Memorandum

Re: Design Development Review of residential development at 201 and 211 North Fork Drive

Figure 1. Overall Layout

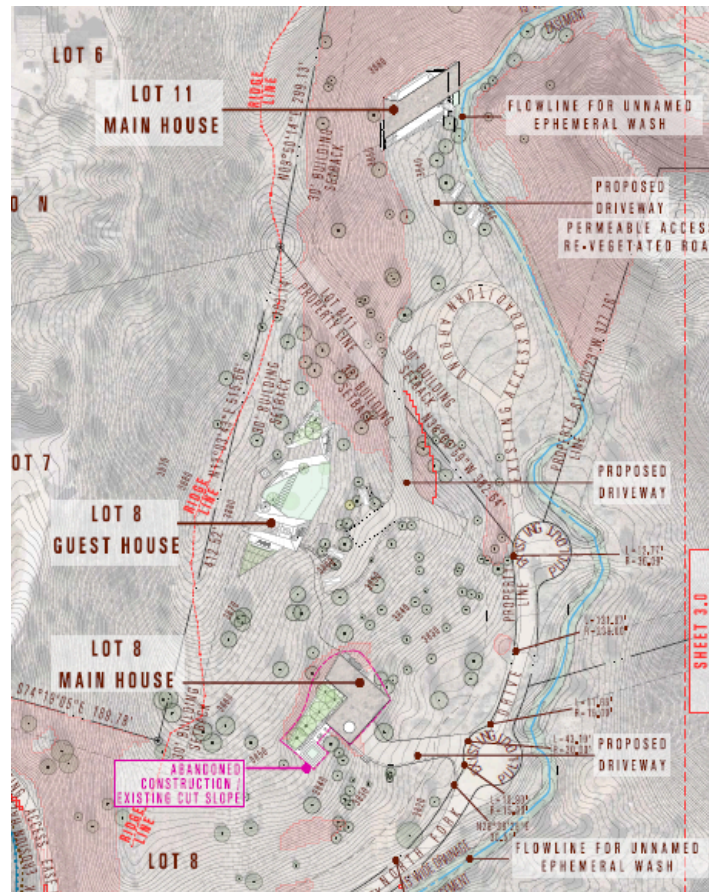
The main house is to be located in the footprint of that original excavation, which is currently in a semi-derelict state. The accessory building/ guesthouse is to be located further up the hill of lot 8. The Town carried out a pole test at this location, and determined that this building would be view-obstructing, but not high visual impact. A separate house is proposed on lot 11.

The Commission will note that the driveway to access the lot 8 guest house traverses slopes which are steeper than 30%. This is generally not permitted by the Town's grading ordinance. A variance was approved in April 2026, which allows the construction of this driveway.
